Proposal for Parallel SCSI: Increase Transfer Rate and Improve Error Detection

To: T10 Technical committee
From: Jim McGrath
Quantum Corporation
500 McCarthy Boulevard
Milpitas, CA USA 95035
Phone: 408-894-4019
Fax: 408-952-3620
Email: jim.mcgrath@quantum.com
Date: June 82, 1998

Rev 2

Figure 2 -- CRC_AVAILABLE timing

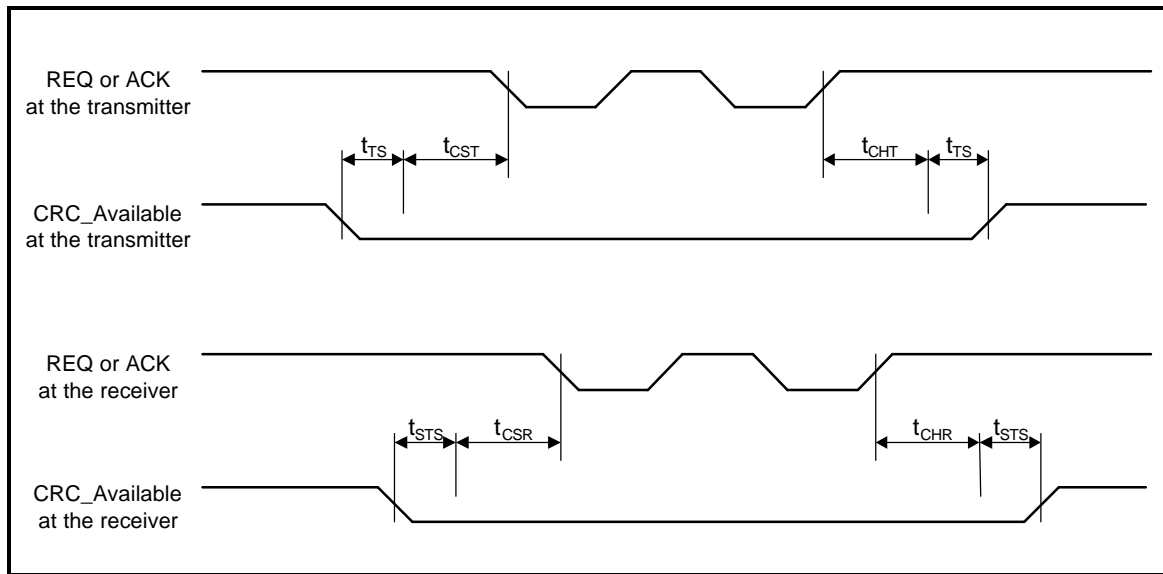
[Note: in the second t_{ST} , there should be additional setup time to allow CRC_AVAILABLE to transition. Following the precedence for setup to CRC_AVAILABLE, it is suggested that an extra 10 ns setup be added here. – CC_AVAILABLE setup time is 10 ns additional on either assert or deassert with request to REQ.]
